LANDMARKS BOARD

STAFF REPORT

LOCATION: 308 W. Commercial Street

**WINDOW REMODEL
FOR
QENOTECA WINE BAR**
308 WEST COMMERCIAL STREET
SPRINGFIELD, MO 65803

3 CASEMENT WINDOW (x3) ENLARGED ELEVATION
1/2"=1'-0"

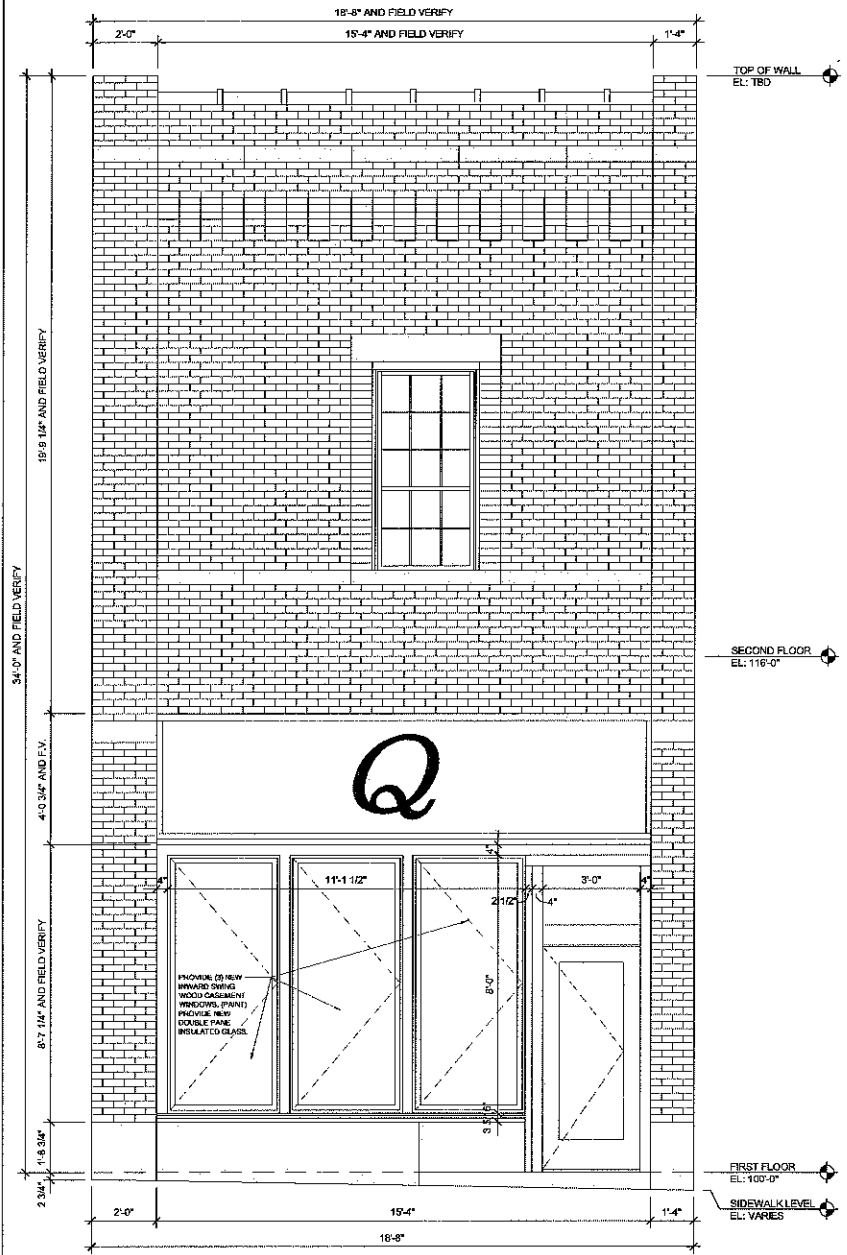
Ms. Lipscomb said her concern is they are going to be operable casement windows in a storefront situation where storefronts are normally fixed panes of glass.

Ms. Lipscomb asked Todd Smith if there was not a way to do that with a normal storefront system instead of casement windows.

Ms. Lipscomb said the new window being proposed is actually wider that what the existing is, because the casements are each measuring 3.6 feet so the casements without any frame are going to be seven (7) feet wide. You are showing a four (4) inch frame on the east side.

2 NORTH ELEVATION - PROPOSED DESIGN
3/8"=1'-0"

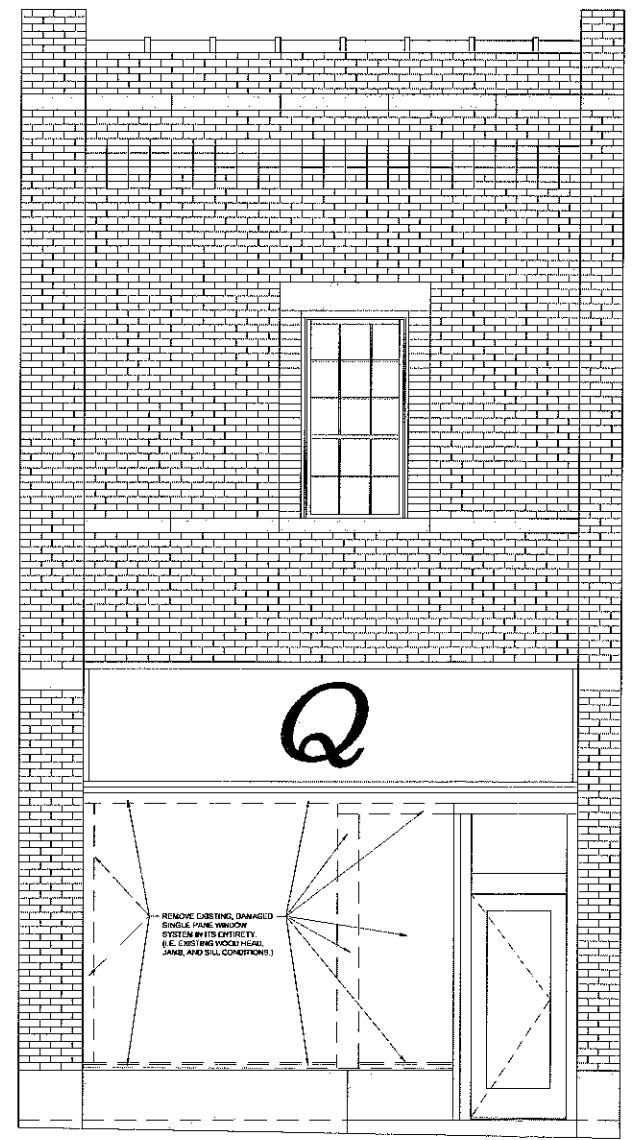
Mr. Eslick reviewed the proposal and the recommendation that the request be denied unless pictorial evidence can be shown to support the new mullions that will be introduced to the storefront. The request is inconsistent with the Secretary of Interior Standards for Rehabilitation and Commercial Street Design Guidelines.

Ms. Lipscomb commented that is the better way to go because you will keep the same rhythm of the glass and the glass pattern for the rest of the storefronts that are in the building.

Mr. Neal said one of the concerns was the additional mullion; the Commercial Street Guidelines don't talk about casement windows and that is the decision the Board would have to make into introducing a casement window rather than a single pane of glass.

Staff recommends **denial** unless pictorial evidence can be shown to support the new mullion that will be added to the storefront.

1 NORTH ELEVATION - DEMOLITION PARAMETERS
3/8"=1'-0"

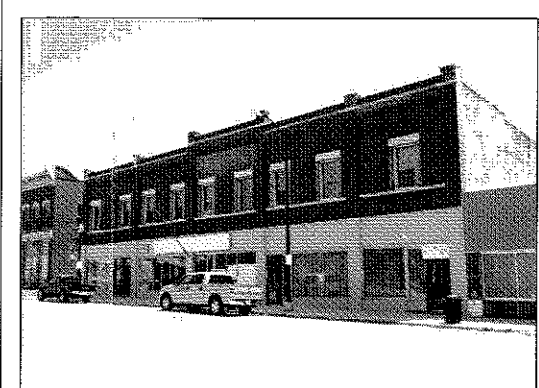
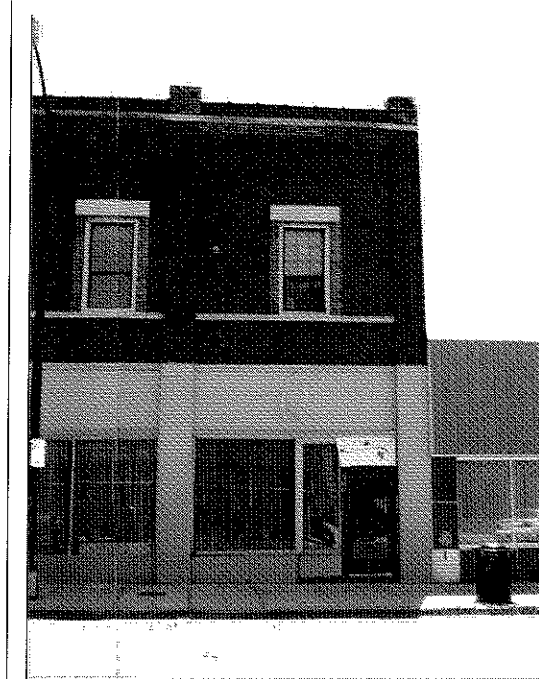
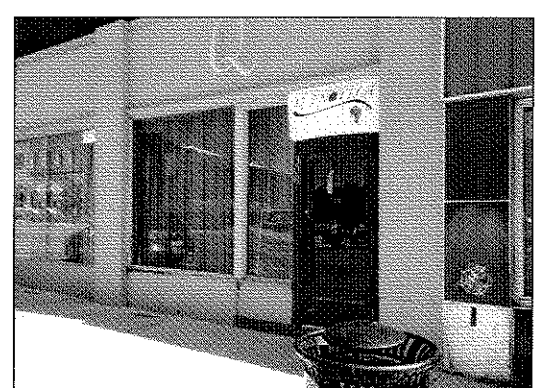
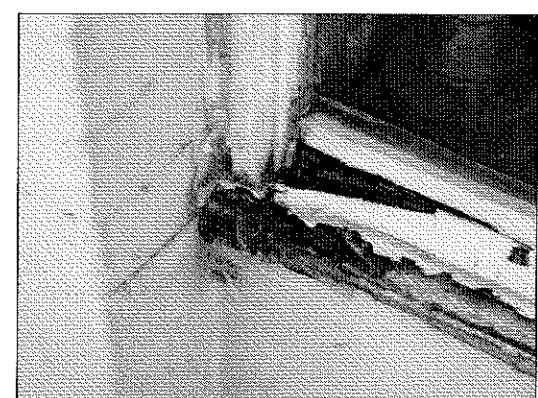
Ms. Lipscomb said she understands what they are trying to do but the sill is rotted and it needs to be replaced no matter what, and from the photograph it looks like it is rotted halfway across, it has completely failed.

Mr. Oke-Thomas asked to look at the existing window, and it already has a mullion in it. The free glass is about seven (7) feet, and we are not counting the mullion. They are not counting from the mullion to the west, that is not included in the dimension so what you have is a free glass that is seven (7) foot wide and eight (8) feet tall and all we want to do is rest on the sill that is already rotted.

Ms. Lipscomb commented the rotten sill will need to be replaced.

GENOTECA - WINE BAR - 308 WEST COMMERCIAL STREET.

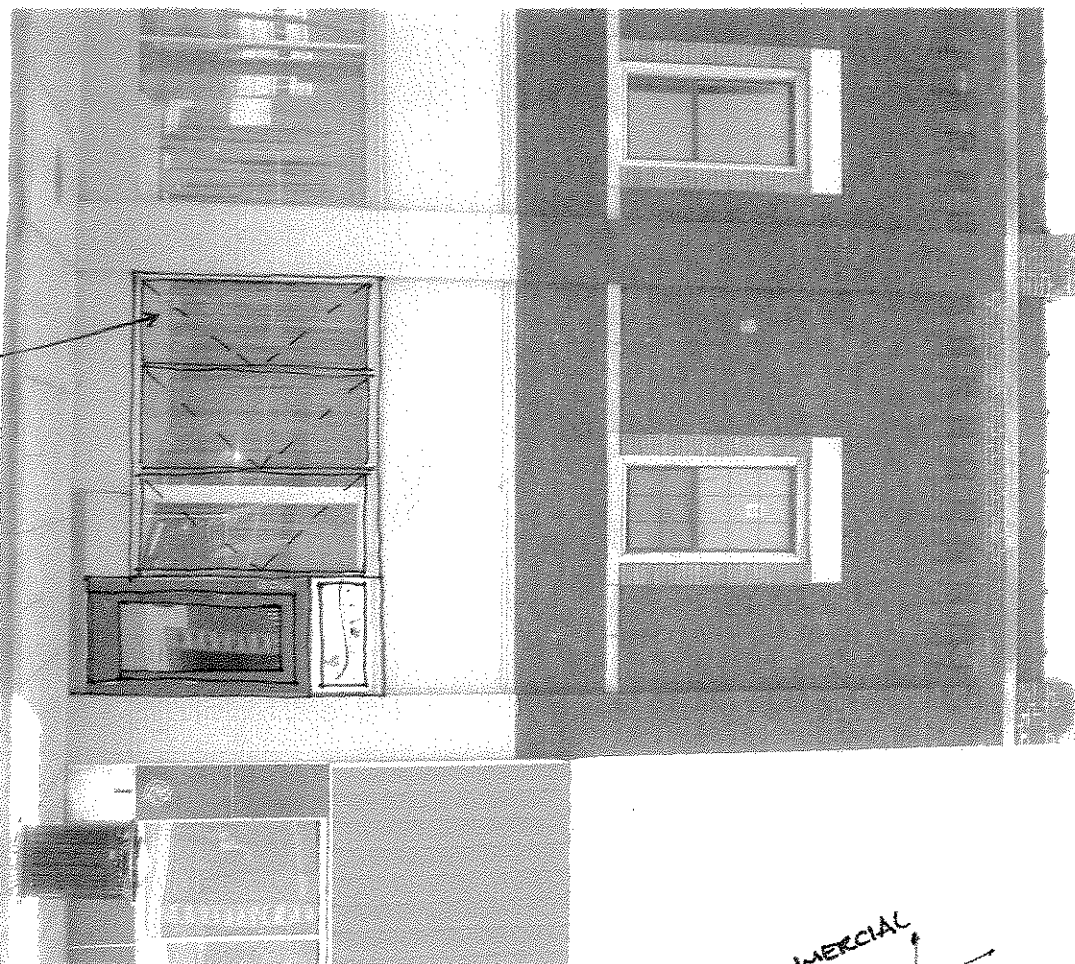
Provide (3) new insulating wood
casement windows. (PAINT)
REMOVE EXISTING, DAMAGED SINGLE
PAVE WINDOW SYSTEM IN ITS
ENTIRETY.
